- 9. Evenson Subdivision 2023 Replat; KPB File 2023-119
McLane Consulting Group / Carroll
Location: Cobbler Lane Off Kalifornsky Beach Road
Kasilof Area**

EVENSON SUBDIVISION 2023 REPLAT

**ITEM #9 - PRELIMINARY PLAT
EVENSON SUBDIVISION 2023 REPLAT**

KPB File No.	2023-119
Plat Committee Meeting:	November 13, 2023
Applicant / Owner:	Royce Carrol of Chula Vista, CA
Surveyor:	James Hall / McLane Consulting Inc.
General Location:	Cobbler Lane Near Mile 1 Kalifornsky Beach Road / Kasilof area

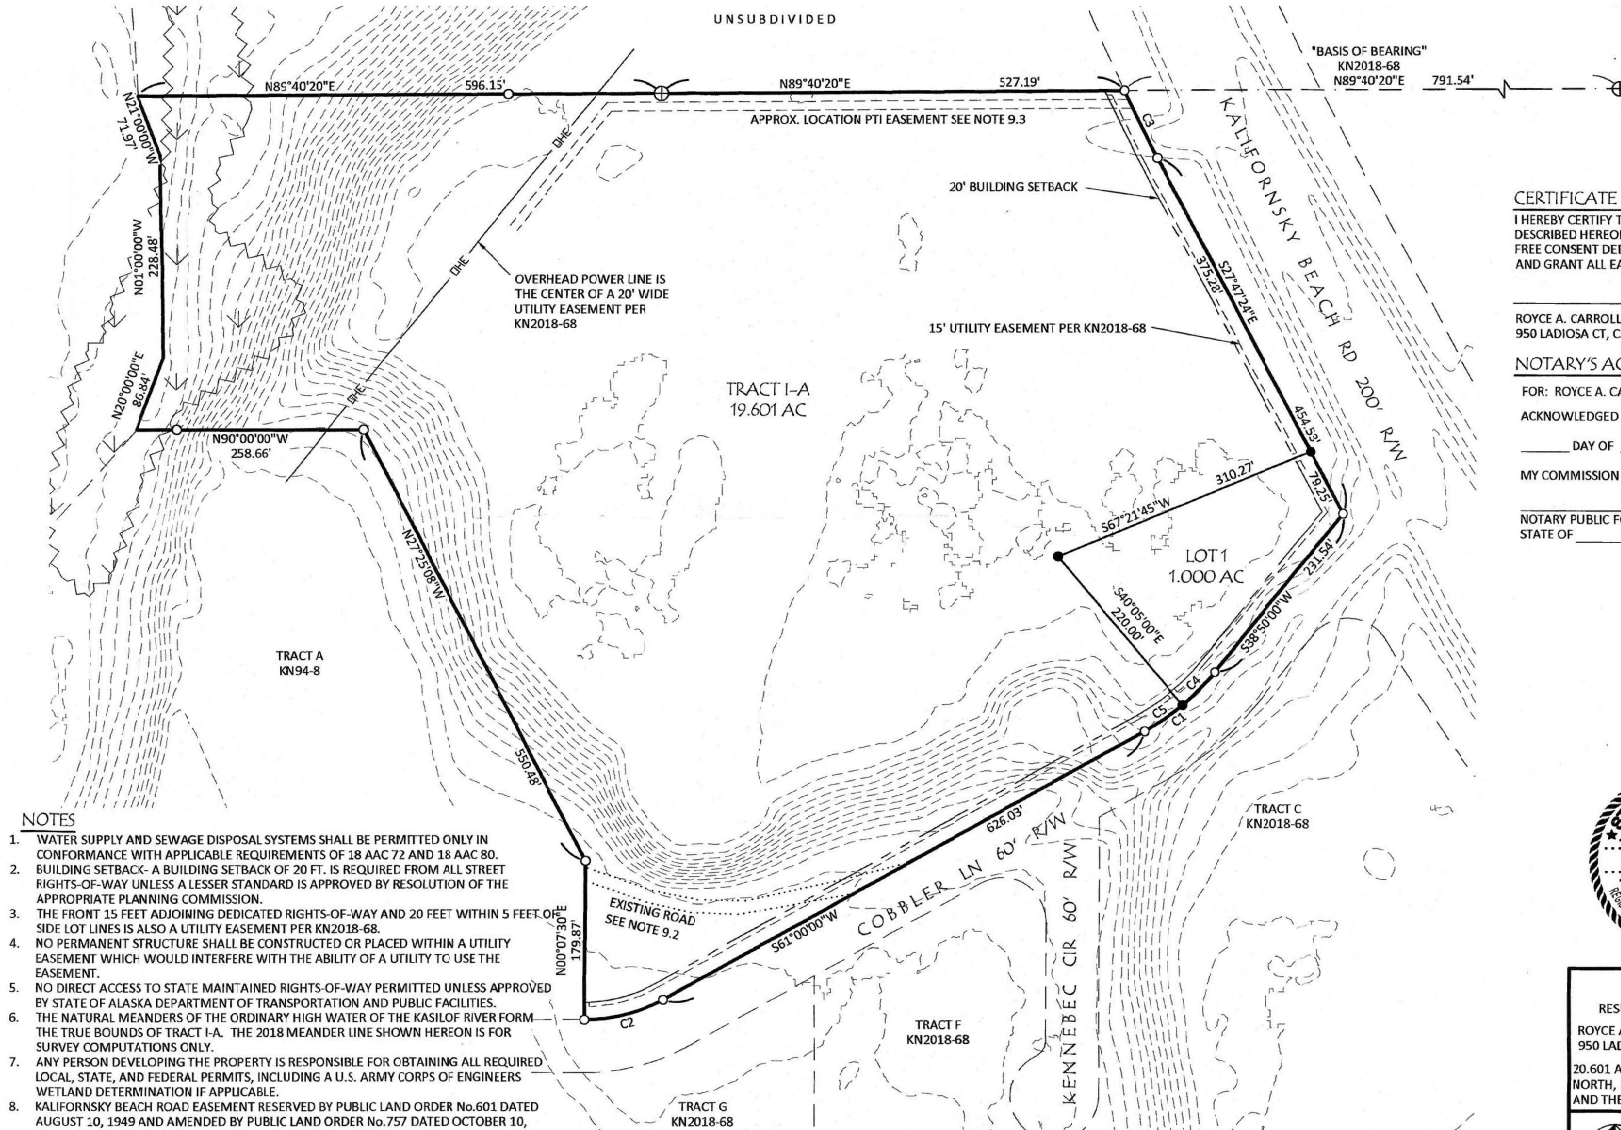
Block length is not compliant. Future development to the north could provide a road. ***Staff recommends: the Plat Committee concur an exception to 20.30.170 is not needed.***

Site Investigation: Steep areas are shown on the subdivision by the contours, but not indicated by the surveyor. ***Staff recommends: the surveyor add top, toe and steep area to the drawing.***

There are areas of wetland not shown and the subdivision is in a flood hazard area and floodway area. The subdivision is also located in the KPB Peninsula Borough Anadromous Habitat Protection District. ***Staff recommends: notes for Flood Hazard notice, Floodway Notice and Anadromous Habitat Protection District be carried forward from the parent plat.***

Plat 2018-68 does not include the bearing and distance to the ¼ corner as shown on the drawing as basis of bearing and referenced to KN2018-68. Please verify information.

- Change KPB File No to 2023-119.
- After 'Resubdivision of' match legal to certificate to plat.
- Check area, differs from parent plat.

- Remove the M/L once surveyed

Staff recommendation: show separate parcel to northwest as Gov't Lot 7

- add reference data and source
- add measured data

- Carry forward notes from the parent plat not already shown.

- Add date of November 13, 2023 to Plat Approval.

- Describe section corners with detail on caps and representation of location identification.
